SUBJECT: WATTS BAR NUCLEAR PLANT, UNITS 1 AND 2 - ISSUANCE OF
AMENDMENT NOS. 131 AND 34 REGARDING CORRECTION TO
UNBALANCED VOLTAGE RELAY INSTRUMENTATION VALUES
(EPID L-2019-LLA-0228)

SAFETY EVALUATION BY THE OFFICE OF NUCLEAR REACTOR REGULATION

RELATED TO AMENDMENT NOS. 131 AND 34

WATTS BAR NUCLEAR PLANT, UNITS 1 AND 2

Figure 1: WBN UVR High Trip Time Delays Relationship

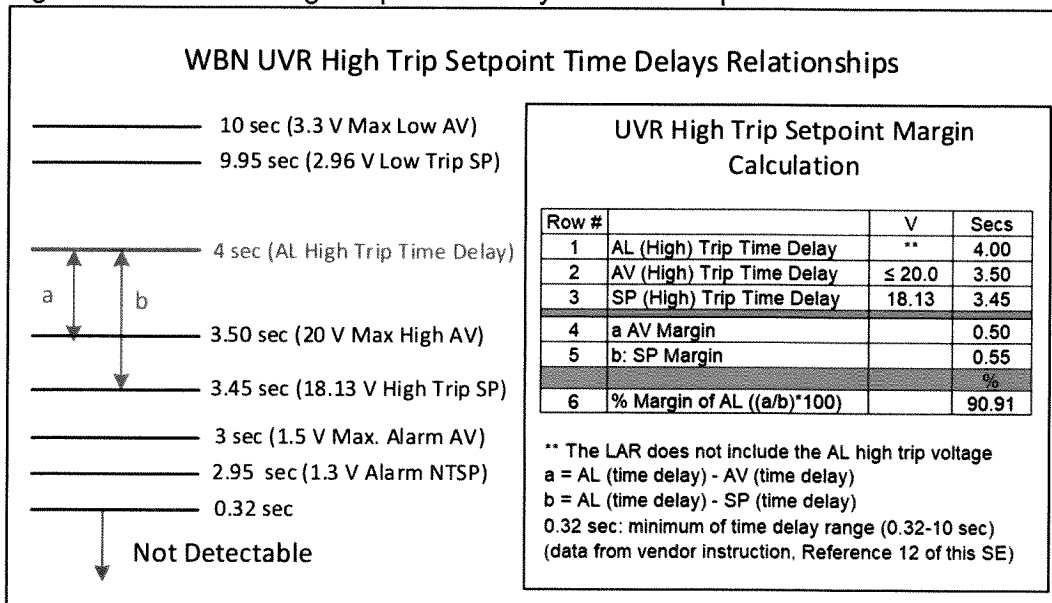
The NRC staff independently evaluated the relationship between the AL, the proposed AV, and proposed Trip Setpoint settings for the UVR (no scale) high trip time delays for the WBN Units 1 and 2, as shown in Figure 1 below:

Based on its independent evaluation, the NRC staff determined the following for the UVR high trip time delays:

- The setpoints lie within the guidance of NEMA MG-1. When the proposed UVR is at the high setting level, the time delay settings are within a few seconds (≤ 4 seconds and ≥ 3 seconds) which would not create significant heat and possibly damage motors.

- The low delay time setting minimizes the heating effects that can degrade motor insulation. The time delays associated with the AVs are longer than the time delays of the Trip Setpoint (of all high, low, or alarm levels) as shown in Figure 1 above and are consistent with the analyses of Section A.4 and the guidance of Relay Timing Period in the Figure A.1 of IEEE Standard 741-1997 (Reference 13).

- The margins (as indicated Rows 4, 5, and 6 in Figure 1 above) are adequate at a value greater than 90 percent to ensure that a trip or safety actuation will occur significantly before the measured process reaches the AL level.

- The proposed time delay settings are also consistent with the guidance of IEEE Standard 3004.8-2016's recommendations pertaining to the relationship between voltage unbalance and negative sequence current magnitude that can degrade motor insulation.

- The proposed AV time delay (3.50 sec) is less than the existing AV time delay (4 sec). The proposed Trip Setpoint time delay (3.45 sec) is less than the existing Trip Setpoint time delay (3.95 sec). Therefore, the proposed time delay settings will be more conservative than the existing time delay settings to the WBN's protection of safety-related equipment from effects of unbalanced voltage conditions originating in the offsite or onsite power systems.

Based on the above discussion, the NRC staff finds that the proposed time delay settings for the UVRs provide reasonable assurance that a trip or safety actuation will occur within the allowable time to protect safety-related equipment. Consequently, an automatic protective action will correct the abnormal situation before a safety limit is exceeded. Therefore, these proposed time delay settings, which are based on the unbalanced voltage value, satisfy the requirements of 10 CFR 50.36(c)(1)(ii)(A) and are acceptable.
